APPLICATION NO.	FILING DATE	FIRST NAMED INVENTOR	ATTORNEY DOCKET NO.	CONFIRMATION NO.
10/627,623	07/28/2003	Reuven Unger	P23593	4331
7055 GREENBLU	7590 03/23/200 JM & BERNSTEIN, P.L.	EXAMINER		
1950 ROLA	ND CLARKE PLACE		GARCIA, ERNESTO	
RESTON, VA 20191		,	ART UNIT	PAPER NUMBER
			3679	
		· · · · · · · · · · · · · · · · · · ·		
SHORTENED STATU	TORY PERIOD OF RESPONSE	NOTIFICATION DATE	DELIVERY MODE	
3	MONTHS ·	03/23/2007	ELECTRONIC

#### **DETAILED ACTION**

Bauer, 3,648,999

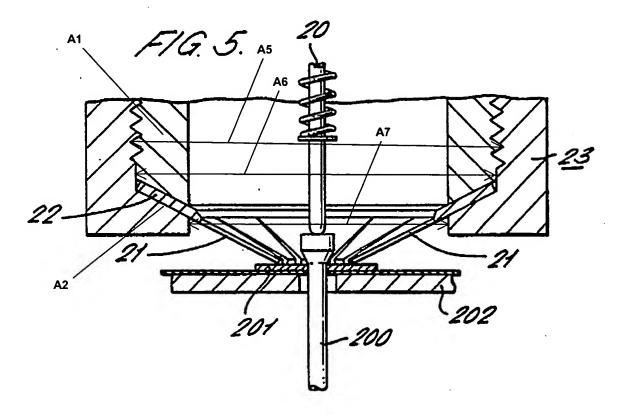
Regarding claim 1, Bauer discloses, in Figure 1, a securing device comprising a spring 15, a rod 18, a generally annular spring support 12 and a generally annular coupling ring A1 (see marked-up attachment). The spring 15 supports the rod 18 at a central portion of the spring and biases the rod 18. The spring support 12 includes a spring mount A2 projecting in an inner side of the spring support 12. An outer peripheral portion of the spring 15 is prevented from movement by the spring support 12 and the coupling ring.

Regarding claim 2, the spring support 12 has a first inner diameter A5 (see marked-up attachment), a second inner diameter A6, and a third inner diameter A7 in this order. The spring mount A2 formed a region between the second inner diameter A6 and the third inner diameter A7.

Regarding claim 26, the spring support 12 and the coupling ring A1 clamp the outer peripheral portion of the spring 15 therebetween.
